Re: Florida Power & Light Company
Proposed Turkey Point Units 6 and 7
Docket Nos. 52-040 and 52-041
Supplemental Submittal to NRC Request for Additional Information Letter No. 64
(eRAI 6544) Related to SRP Section 03.05.03 - Barrier Design Procedures

"Supplement to RAI-6544", TPG-GW-GLR-001

SRP Section: 03.05.03 – Barrier Design Procedures

NRC RAI Number: 03.05.03-34

Figure 2 – Automobile Horizontal Hurricane Impact Force

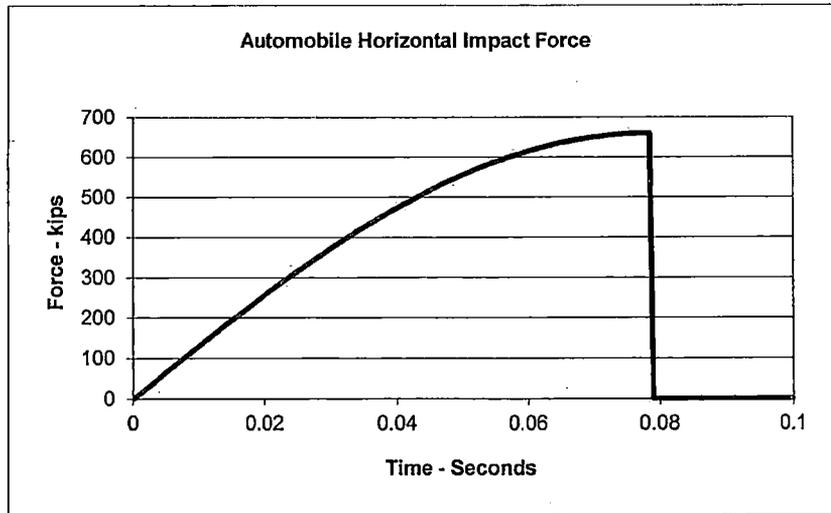
The plot of this forcing function considering horizontal impact is shown in Figure 1. The frontal impact area is 6.6 feet x 4.3 feet as per Regulatory Guide 1.221, Revision 0, October 2011.

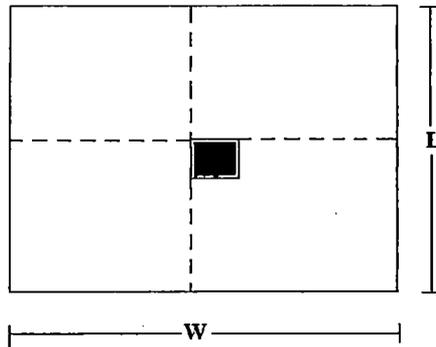
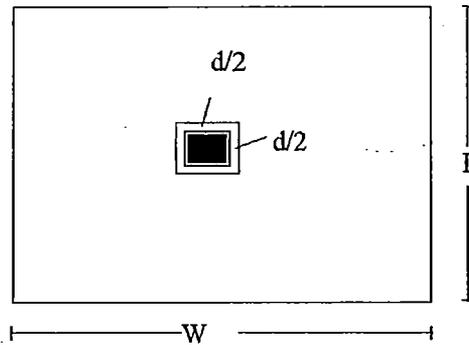
Using Wall 5 as an example, illustrate the calculation of the allowable shear for one-way and two-way action. Illustrate how b_o and b_w are obtained and used.

Wall 5 is used as an example to demonstrate how the shear allowable is calculated for one-way and two-way shear. Shear allowables are in compliance with ACI 349-01.

b_w is the minimum of the width (W) or length (L) of the slab. d is the distance from extreme compression fiber to centroid of longitudinal tension reinforcement.

b_o is the perimeter of the critical section of the slab. d is the distance from extreme compression fiber to centroid of longitudinal tension reinforcement.
